UNITED STATES ENVIRONMENTAL PROTECTION AGENCY
REGION 5
77 WEST JACKSON BOULEVARD
CHICAGO, IL 60604-3590

July 12, 2021

**Subject: Review of Groundwater Monitoring Report for Semi-Annual Monitoring Event
November 2020
Southeast Rockford Groundwater Contamination Site**

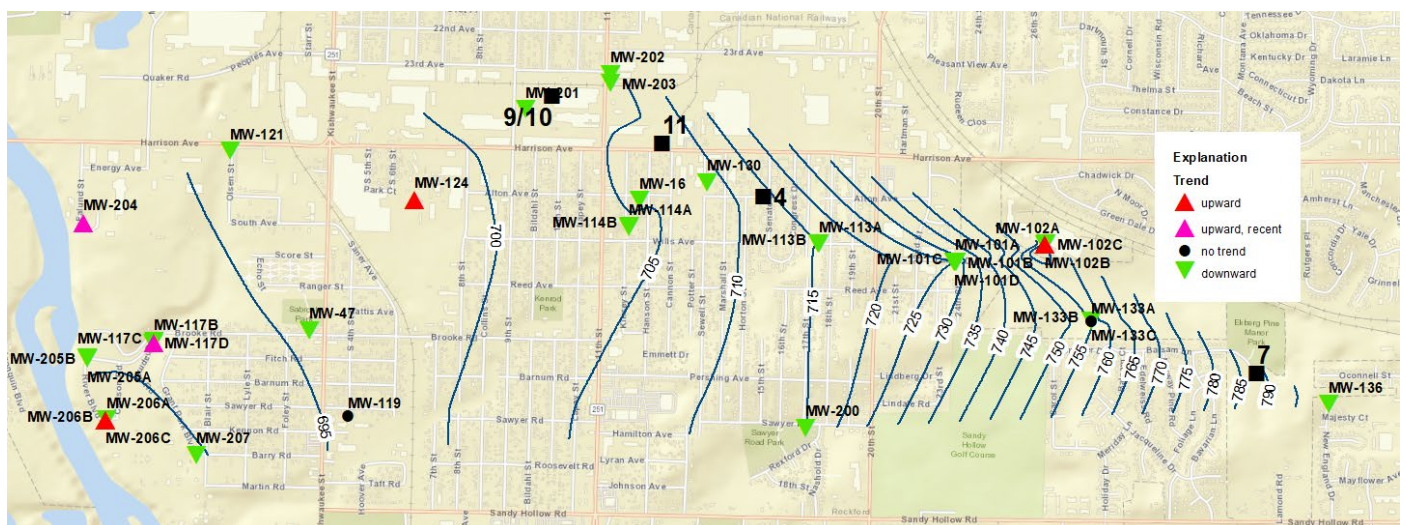
1. The site boundaries for SERGCSS are as defined in the 1995 OU2 Record of Decision (ROD). "The study area was later expanded to an area of ten square miles with boundaries that now include Broadway to the north, Sandy Hollow Road to the south, Mulford Road to the east and the Rock River to the west. The original site boundaries and current study area are noted on page 2 (Page 1 of 1995 OU2 ROD)."

Remove the "study area" outline in Figure 1 and legend description and replace with the "site boundary" as defined above. This is a global comment for all future figures involving the boundary of SERGCSS. This is important as other stakeholders, such as Illinois Department of Public Health have recently used these semi-annual groundwater reports to delineate the site; the "study area" is incorrect.

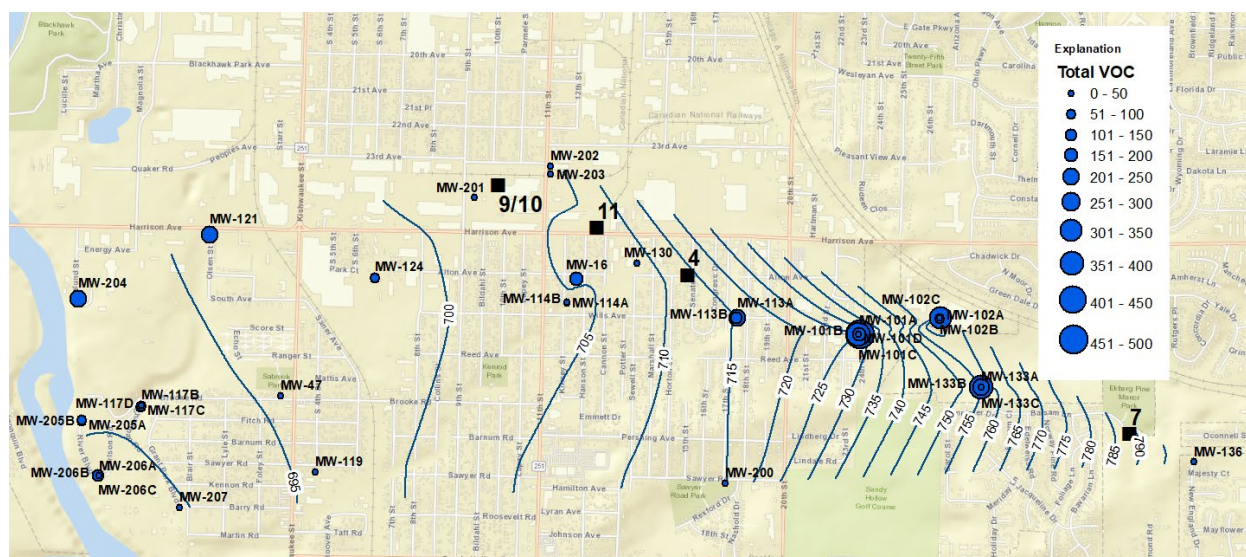
- a. A spatial plot of the trend direction (trend of up, down, or none for the recent past) could help reveal where problem areas are in one graphic. The plot below is of their linear trends as presented in Figure 2; not the recent past trend except for MW 204 and MW-117B.

- b. This plot combined with a plot of the magnitude of the most recent total VOC (see below) can further refine where the larger problem areas are in a more spatial way.
